## Blackjack 24 RTR Radio Tray Addendum

**Products:** PRB Blackjack 24™ (PRB08007)

**Issue:** Some boats may have loose radio trays.

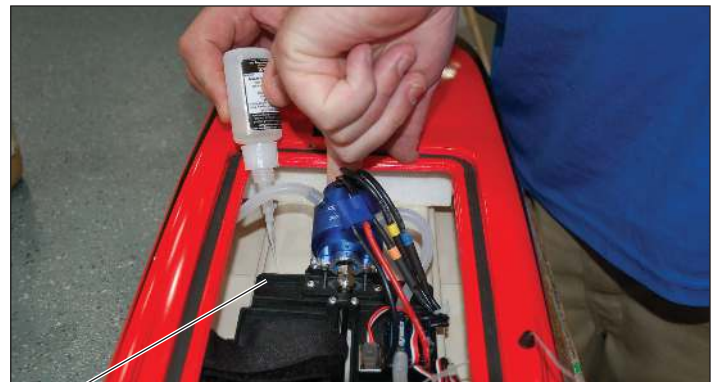
1. Pulling on the battery straps may loosen the radio tray from the hull.
2. If the radio tray becomes loose, apply CA (cyanoacrylate adhesive) between the tray and the hull as shown in these photos.

**IMPORTANT:** The motor is connected to the shaft, holding the tray in the hull. Carefully lift the tray while applying adhesive.

**What to Do:** Inspected radio trays are marked with a green dot as shown in this photo and are correct. If there is no inspection mark, check to make sure the radio tray is firmly attached to the hull.  
Contact Horizon Hobby Product Support if you have any questions.

Carefully lift the radio tray up and apply CA between the tray and Hull
